10/802,177

Timothy W. Mehnert

Office Action Summary

DETAILED ACTION

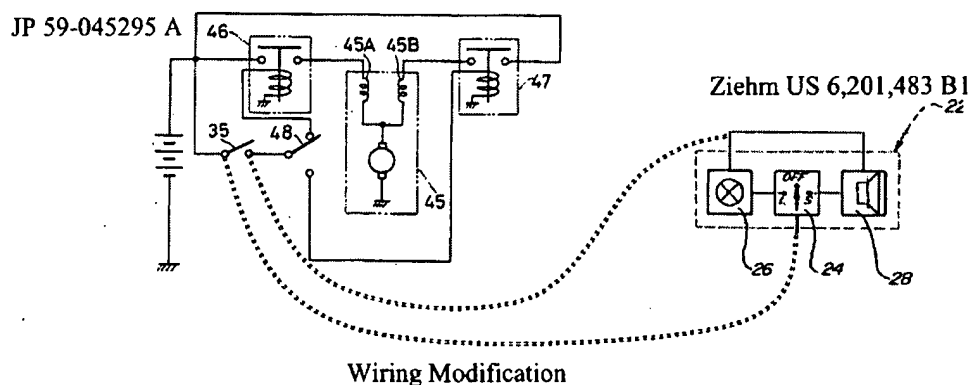
JP ('295) shows an apparatus comprising a cam [40] coupled to a steering linkage bar [18] of a watercraft, and a switch [35] coupled to a fixed portion of the watercraft (figures 1, 2 and 3). The switch is activated when the outboard motor of the watercraft is in a centered position, and allows a tilting operation of the motor only when such motor – and therefore the rudder of a watercraft -- is in a centered position. When not activated, the switch does not allow a tilting operation of the motor.

JP ('295), however, does not provide any visual or audio confirmation to the operator when the motor reaches a centered position. Specifically, JP ('295) is silent on:

- (i) the switch being electrically connected to an indicator light, or
- (ii) an indicator, in the form of an indicator light, being located on a dash of the watercraft.

Ziehm shows boat having an indicator system to signal a centered position of a steering. The indicator system has an indicator light [26] that is activated by an electrically-connected switch [18] when the steering is in a centered position (col. 1, lines 36-48). The indicator light is

It would have been obvious for one skilled in the art at the time of the invention to connect an indicator light to the center-detecting switch of JP ('295), as taught by Ziehm. Having such indicator light would have been desirable to alert the operator of a malfunction in the tilting apparatus of the outboard motor. Such modification to JP ('295), as taught by Ziehm, would have helped a boat operator recognize that the tilting mechanism would respond only when the indicator light was illuminated. However, if the tilting mechanism failed to respond even when the indicator light was illuminated, it would clearly indicate a malfunctioning of the tilting mechanism.

As an additional advantage, such indicator light would have also provided a navigational assist mechanism for guiding the watercraft in a straight direction even in poor visibility conditions such as fog or darkness, which would have further improved the operational safety of the craft (*see below for a simplified illustration of one possible modification of JP '295, as modified by Ziehm*).

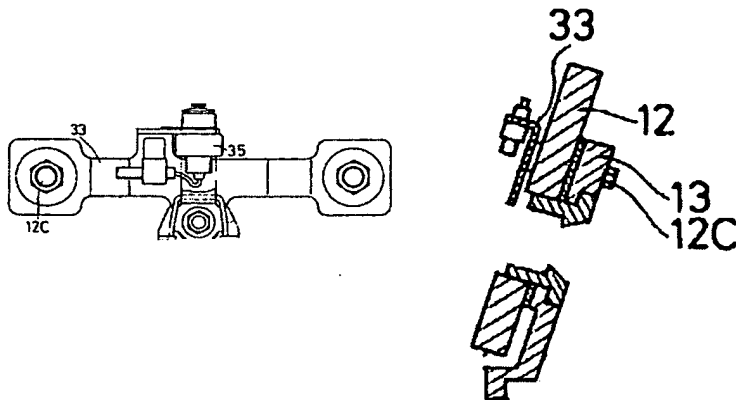
Re claim 2, the cam is coupled to the steering linkage bar via a clamp [43]. The phrase "clamp hose" has been broadly interpreted to mean a clamp that is capable of attaching over a tubular, or a hose shaped, structure. The clamp of JP ('295) meets such criterion, and is therefore considered to be a clamp hose.

Re claim 3, the switch is coupled to a fixed portion [12] of the watercraft by at least one bracket [33].

Re claim 4, small switches that are operative as "push button" or "snap-action" switches are commonly known as microswitches. The switch of JP ('295) meets such criteria, and is therefore considered to be a microswitch.

Re claim 6, the apparatus comprises a plurality of brackets [33,13], wherein a second bracket [13] and nut-bolt fasteners [12C] are employed to secure the first bracket [33] to the fixed portion of the watercraft. The switch – which itself is mounted on the first bracket – is therefore considered to be secured to the fixed portion of the watercraft by the first and second brackets. (*see simplified illustration below, as modified from figures 1 and 2*).

Further, a loosening of the bolts would allow both brackets to shift relative to the fixed portion of the watercraft, and would correspondingly change the position of the switch. Therefore, the brackets are considered as being adjustable by loosening of the nut-bolt fasteners, which will adjust the "sensitivity" of the switch, as broadly interpreted above.

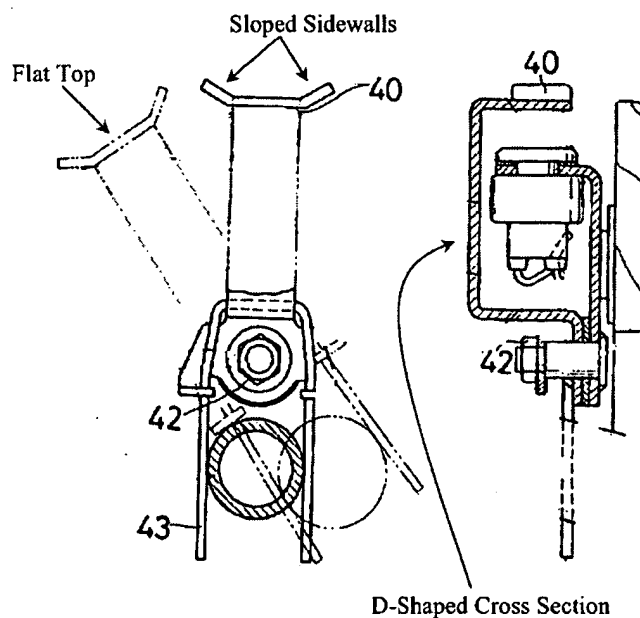
Re claims 7, 10 and 11, the cam includes two sloped sidewalls, joined by a flat top portion. The cam has a substantially D-shaped cross-section. (*see simplified illustration below, as modified from figures 2 and 3*)
